# 47TH STREET REPAVING AND TRAFFIC SAFETY PROJECT

## 800 BLOCK OF S 47TH STREET

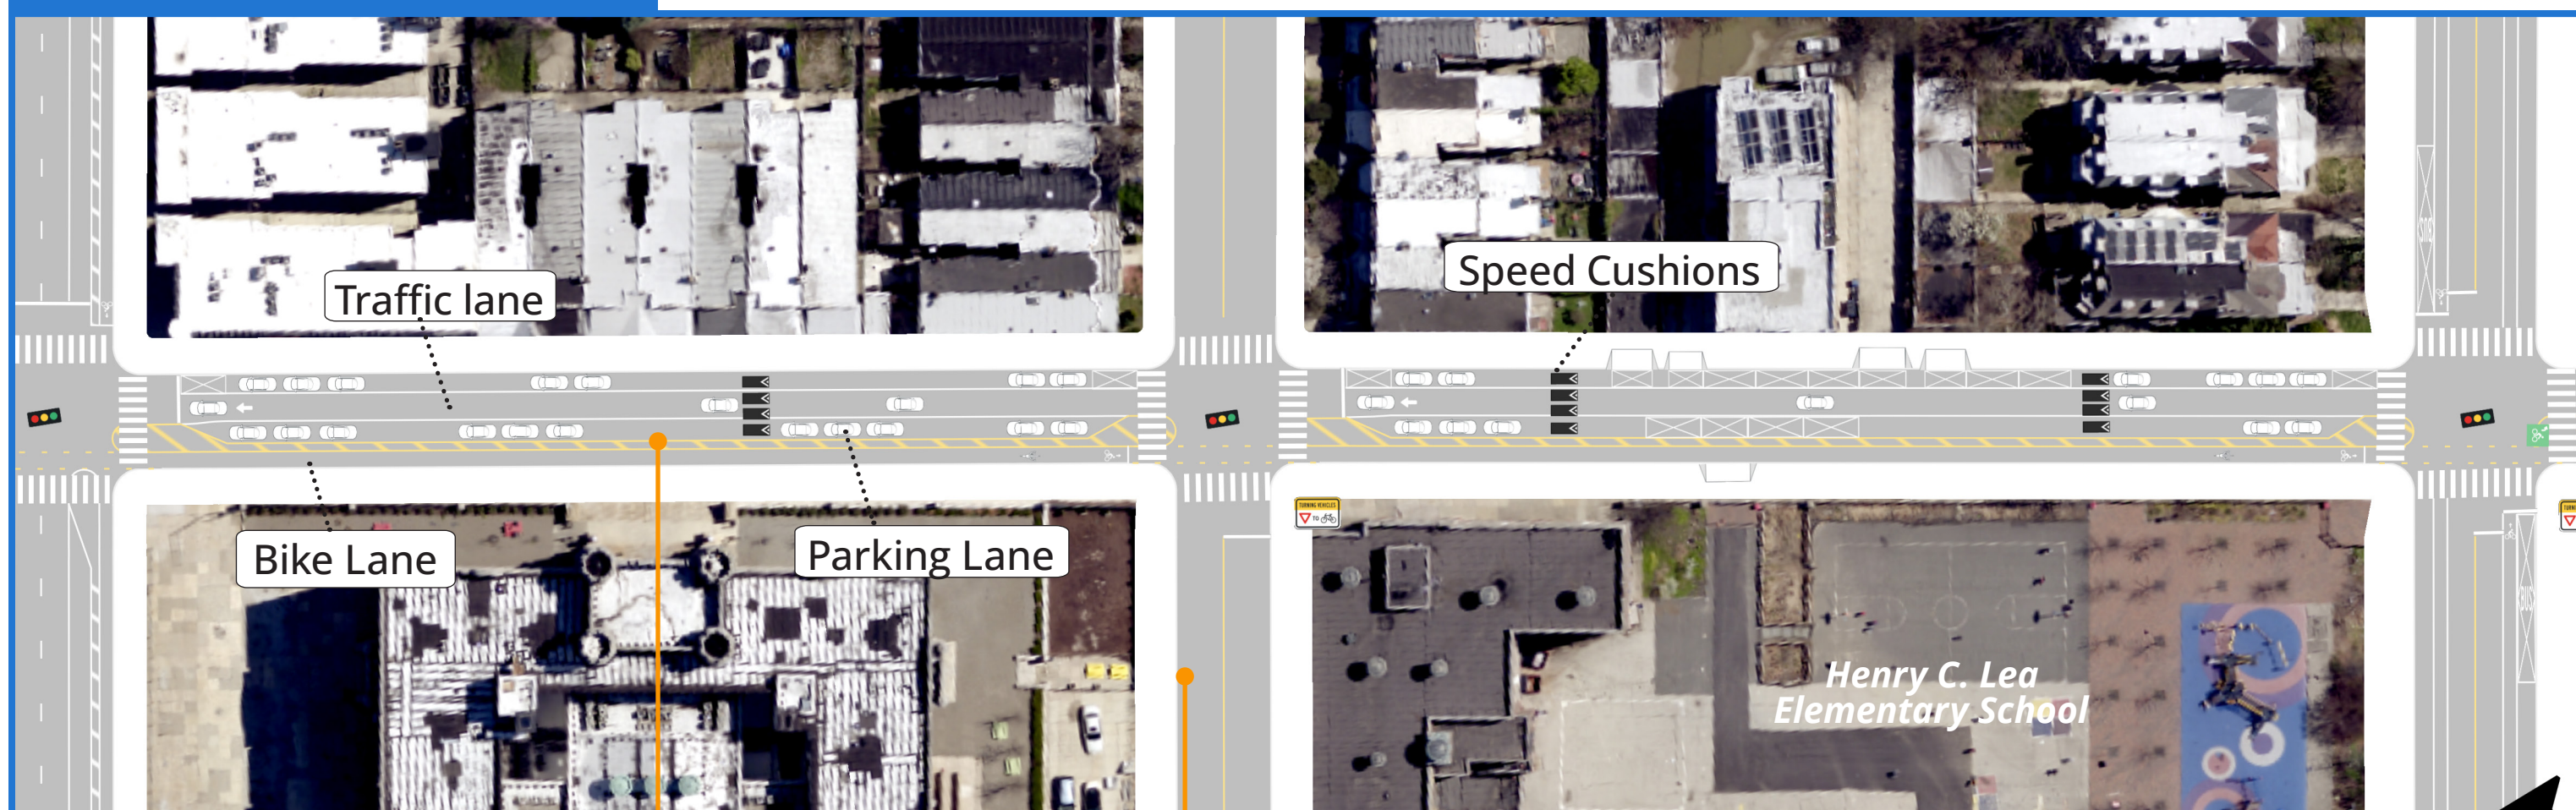
A loading zone is needed here for West Loft deliveries and drop off and pick ups

Consider new No Stopping School Hours layout to better organize drop off and pick up by vehicle

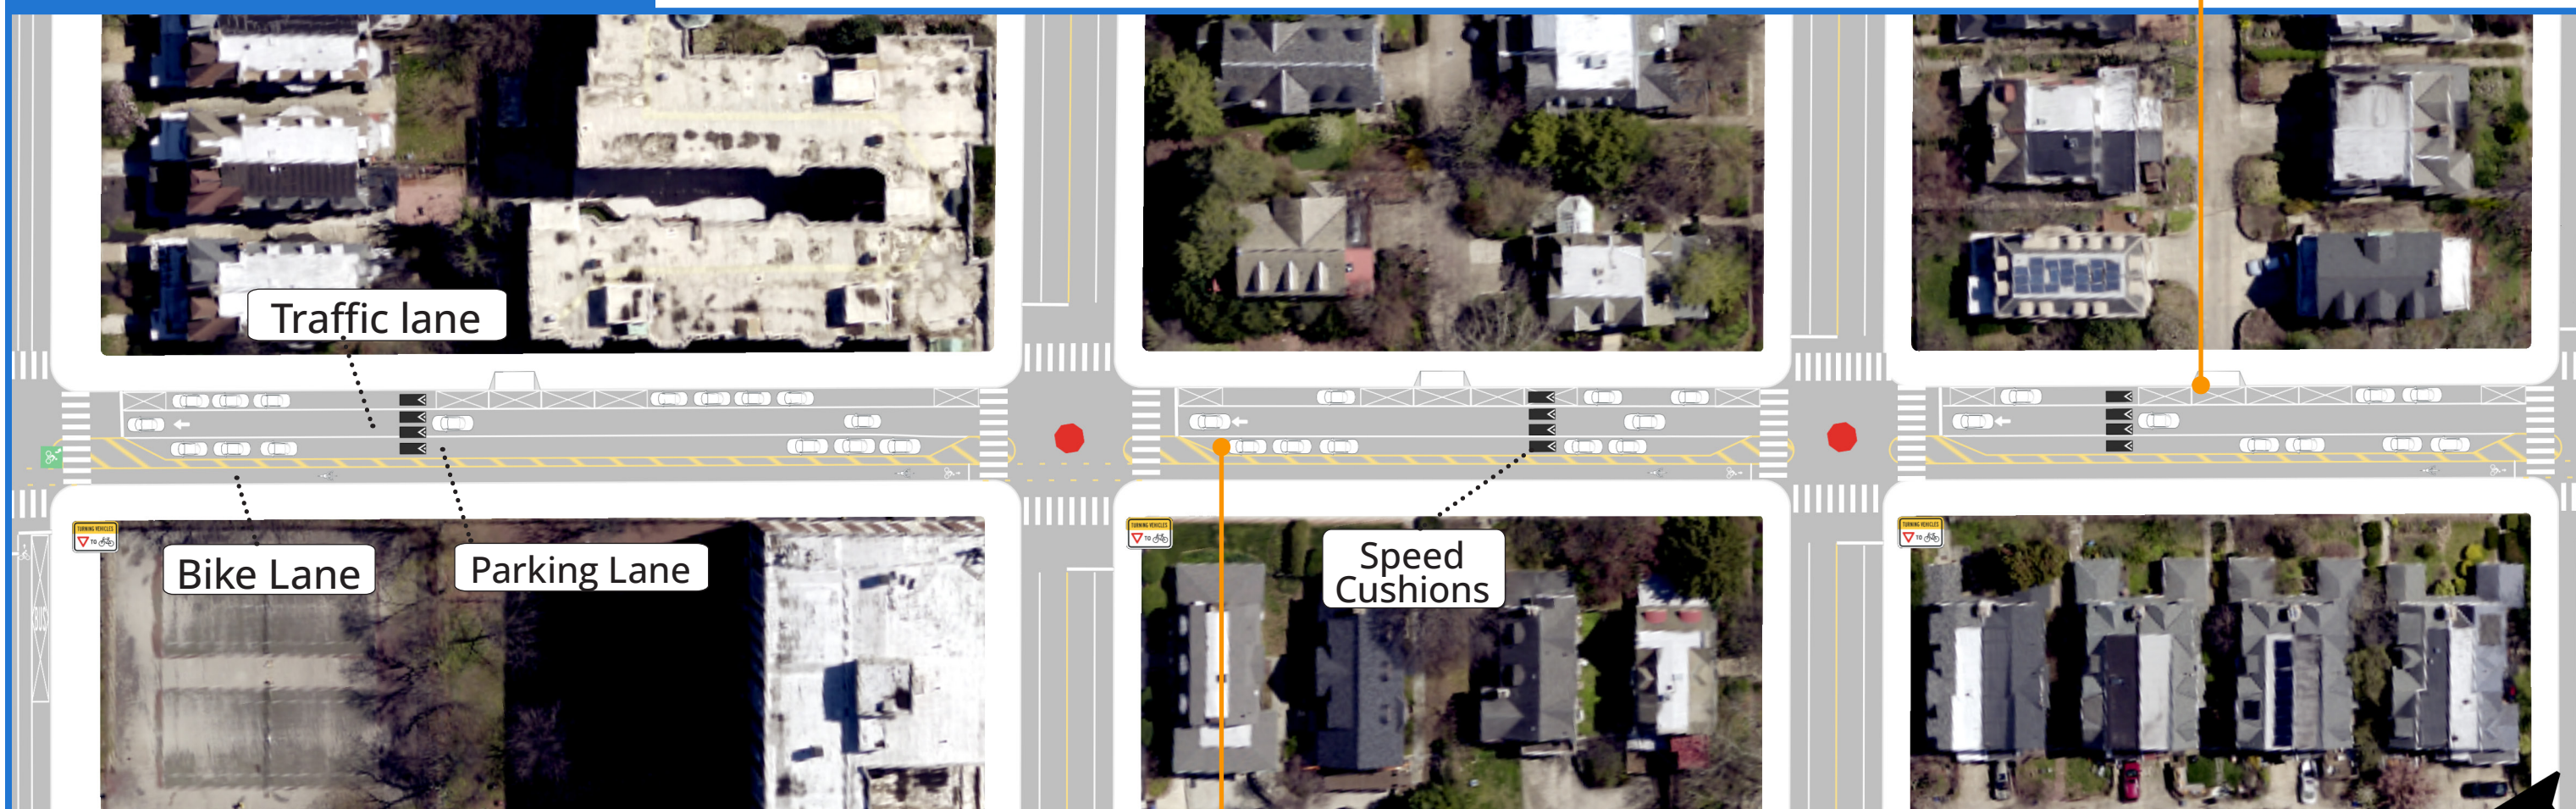
Add 1-2 loading zone spots per block with nighttime parking

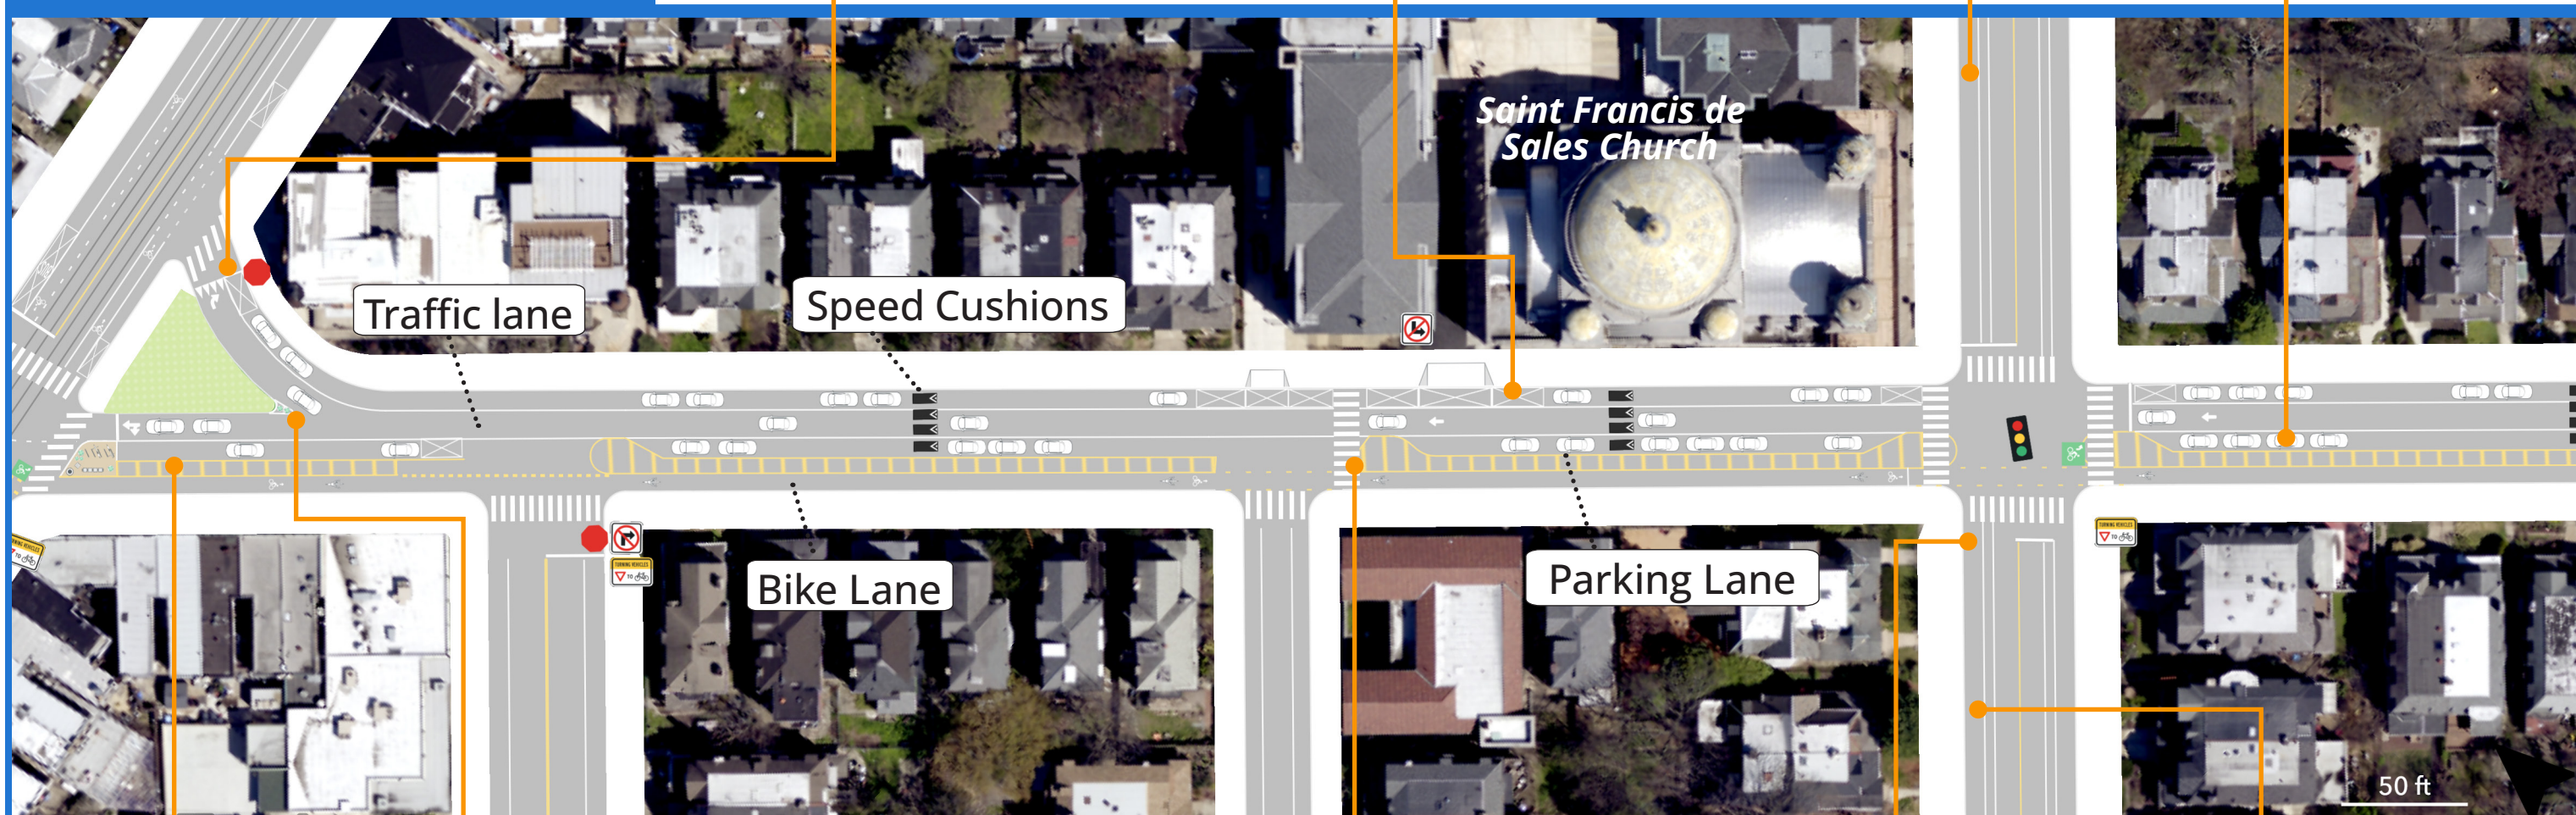
Drivers don't always stop at this stop sign, consider more traffic calming here

Parking enforcement is needed here so parents can drop off and pick up kids NOT in the roadway

Add more No Stopping School Hours space here

Add loading zone spaces here at the Senior Center

Business loading is needed here

Close this slip lane for traffic safety

Add a stop sign and cross walk here for school drop off and pick up safety

Consider making this a stop sign instead of a signal for traffic safety

Add more No Stopping School Hours here

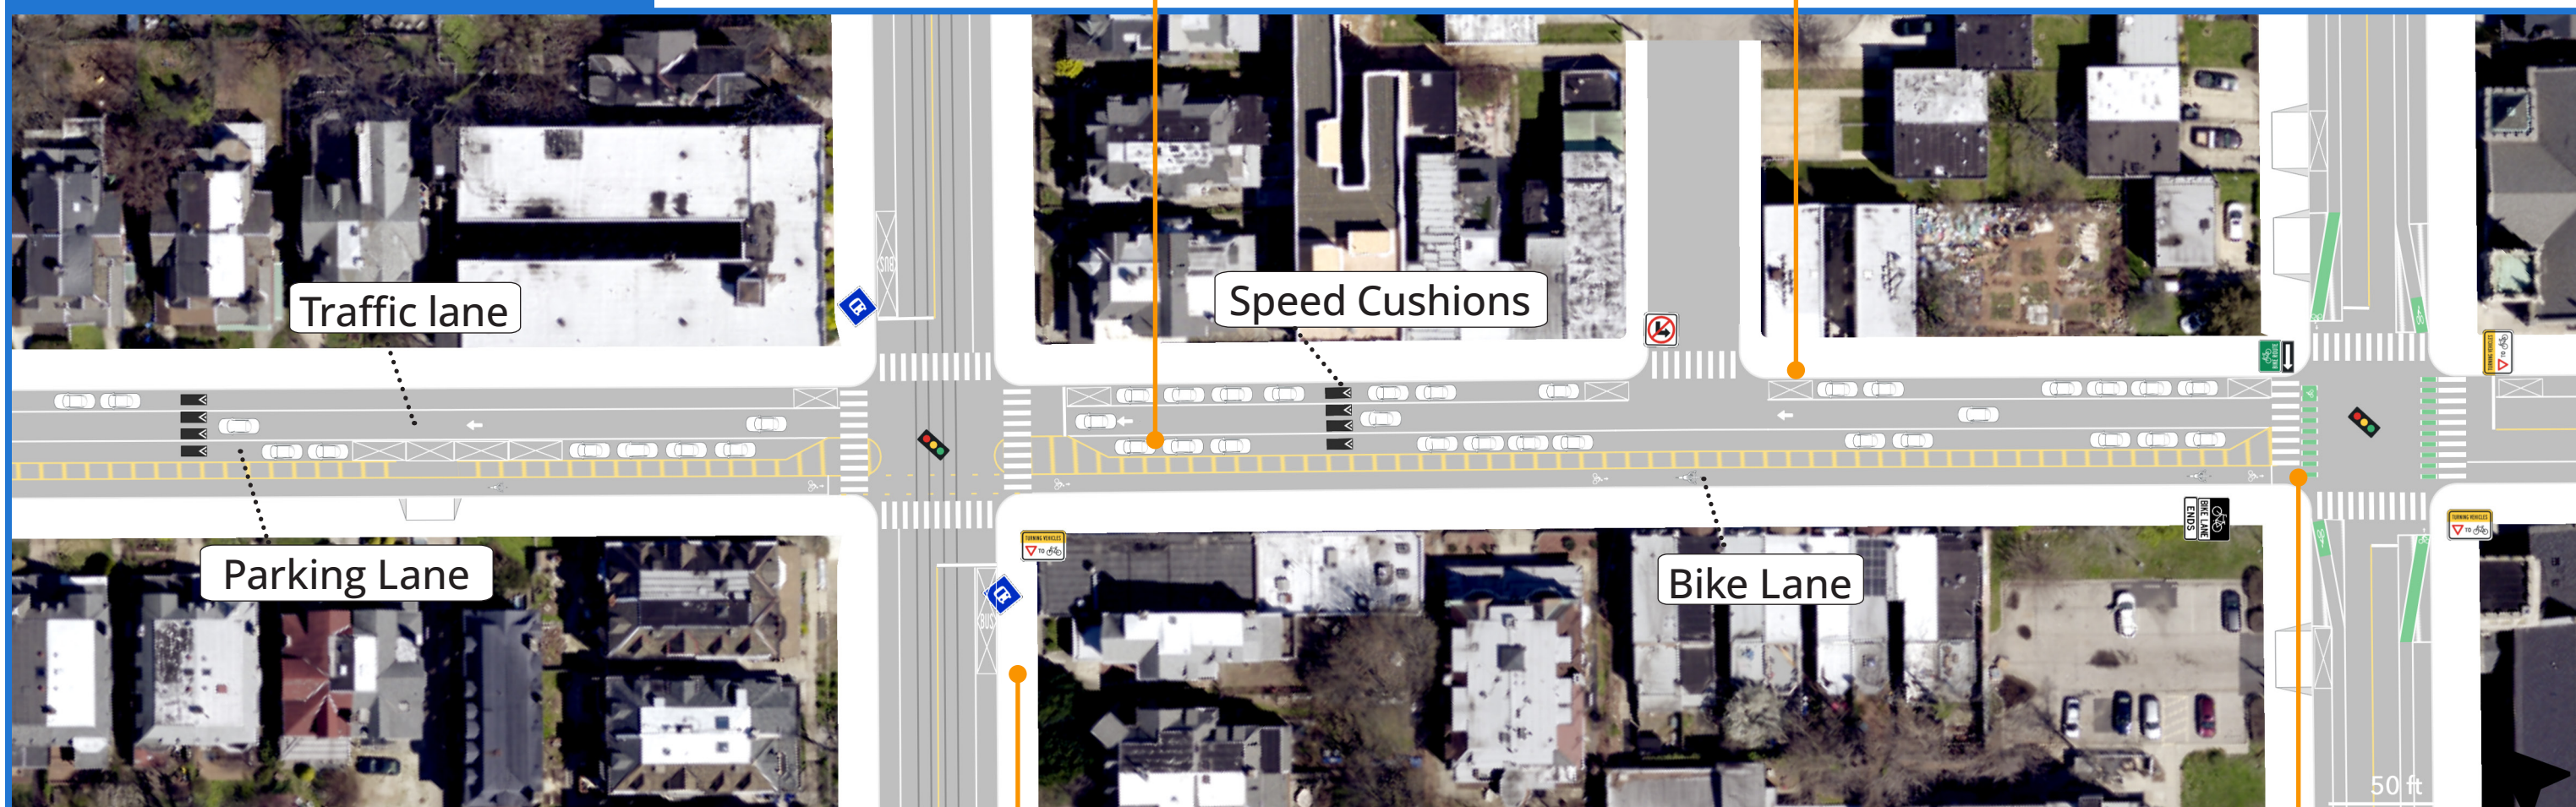
Add loading here, lots of commercial

Keep these X boxes clear with flex posts so that people driving out of Regent can see oncoming traffic

Shops load in the trolley stop today, add loading zones

Lots of families crossing here to kindergarten
